CITY OF ALBUQUERQUE

Planning Department
David Campbell, Director

**RE: Lot 3 Block 10 Unit 22, S.A.D. 228
Volcano Cliffs Subdivision
6424 Petirrojo Rd. NW
Grading and Drainage Plan
Engineers Stamp Date; 5-17-18 (D10D003F3)
Pad Certification Date; 6/15/18**

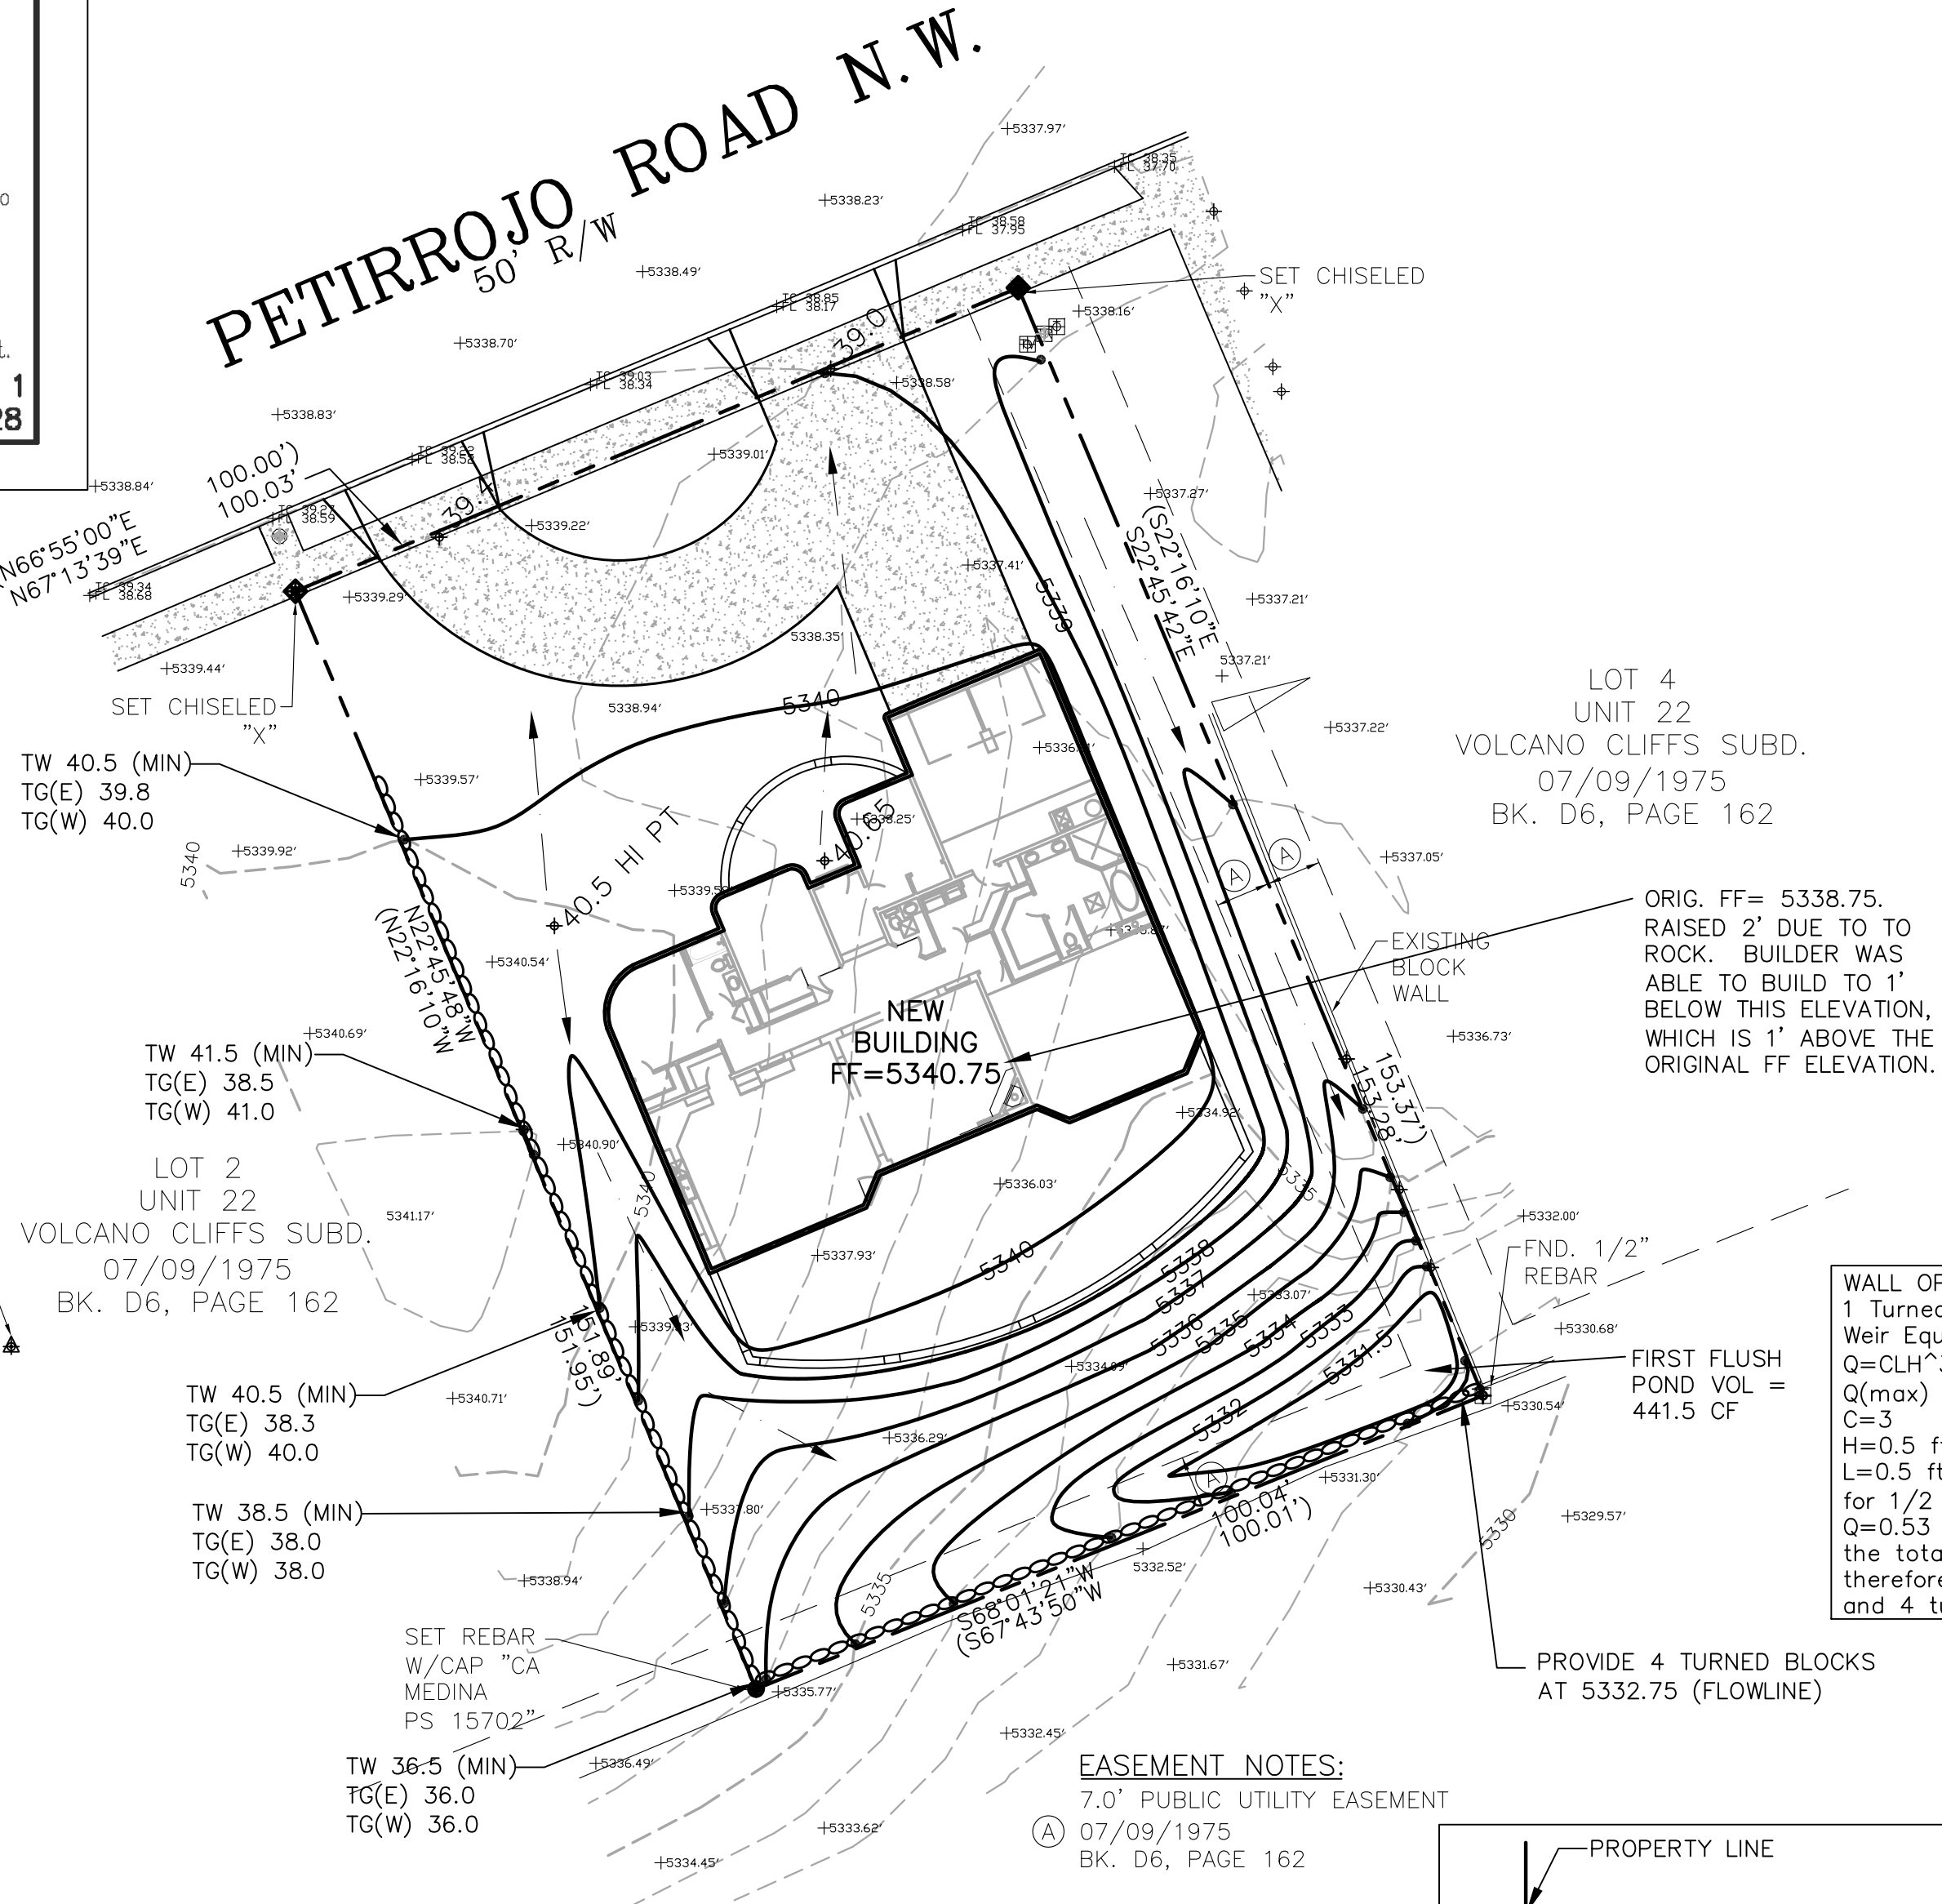
Based upon the information provided in your submittal received 7/6/18, this plan is approved for Building Permit.

Please have the owner/builder attach a copy of this approved plan, to the construction sets in the permitting process prior to sign-off by Hydrology. Reiterate to the Owner/Contractor that a separate permit for a garden/retaining wall must be obtained, with the approved G&D plan dated 2/9/18.

Prior to Certificate of Occupancy release, Engineer Certification per the DPM checklist of this plan will be required.
